LEAD WIRE SHIELD - MERC 200 - 110 - 60

Figure 8. Merc 200 Wire Shield (34674A1) - Merc 110 & 60 Wire Shield (35599A1)

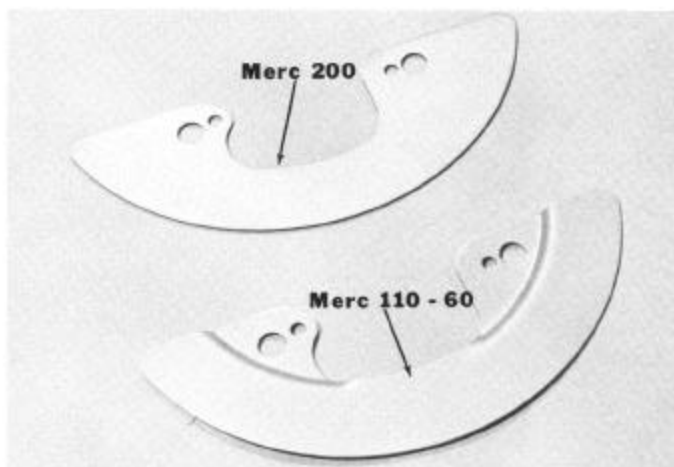
Production is now installing a lead wire shield on the magneto stator plate of all Merc 200-110 & 60 motors. This shield prevents the flywheel from rubbing or chafing, with subsequent shorting of spark plug leads which may have been improperly positioned.

NOTE: Merc 200 requires lead wire shield 34674A1. (Figure 8) Merc 110 & 60 require lead wire shield 35599A1 which is offset to provide necessary clearance for the flywheel. (Figure 8)

Figure 9. Wire Shield (35599A1) in Position

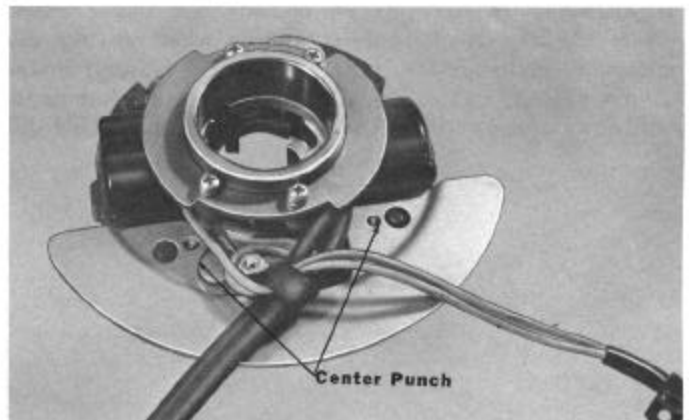
1. Remove magneto stator and stator hold-down ring.
2. Use lead wire shield as a template. Place shield in

position, as shown in Figures 9 & 10, and center punch screw holes.
